7/5/17 STU'S COMMENTS + QUESTION

Memorial Pool Bath House Program 7/5/17

Here are some notes on the bathhouse sketch.

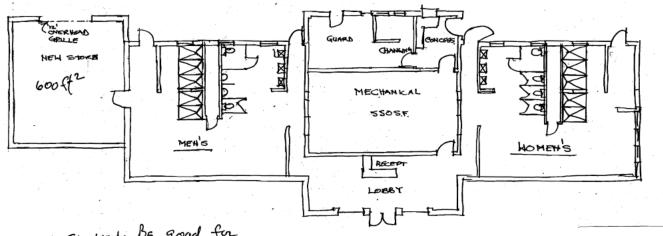
WHAT IS TOTAL SO FOUTAGE
WE NEED TO FUND SPACE FUN FAMILY/HANDLAD CHANGING ROOM PERHAPS 2 x 120/22 (MILEX)
WHAT Are the areas of the locker Rums?

Ex world BE good for GUARD OFFICE to also open yo to libbay -

The mechanist Ram is JUST A real chillenge Rightin the Mipple -Accest/Chemist Sprage/ - Nees to move this -I still like a separate or New space =

- 1. The location of the mechanical room is still problematic in the current bathhouse. With all new plumbing for the pool, we are probably better off creating a new mechanical room to better meet code and support the staff operation. We need to factor in the following elements:

- a. Access to the room for maintenance and repair without going through entrance
 - b. Need to have chemical storage accessible for deliveries. Right now the chemical storage rooms I believe are on the right side of the building.

- i. The required two separate storage rooms should be sketched in
 - c. Perhaps the mechanical room can be an extension like the storage on the other end of the building

- i. NOTE: Most of the design items we had discussed through the summer and fall featured a new mechanical/pump room. The location in the current bathhouse is such an operational nightmare.

- d. The location of the mechanical room needs to be addressed. May be better to move the mechanical room and not deal with any reconfiguration of the locker rooms that may add cost.

- **e.** Based on what we have seen at the other city pools and other facilities, we may be able to carve some family changing space out of the locker room. The Memorial locker rooms are pretty big, bigger than those at Erickson and Northside.

- 2. We need to have at least two family/unisex changing rooms for families. These only need to be about 120 sq ft each with toilet, sink, and shower. These can be along the corridors to the pool and take the place of the mechanical room.

- 3. The Guard office should also have access to the reception lobby. It is important that the guard office connects since there will be questions, communication, and some swing shift coverage of reception from the guard room. This will streamline management and staff efficiency. There will also be people that want something from concessions when they come into the lobby, so it is good to have the pass-throughs.
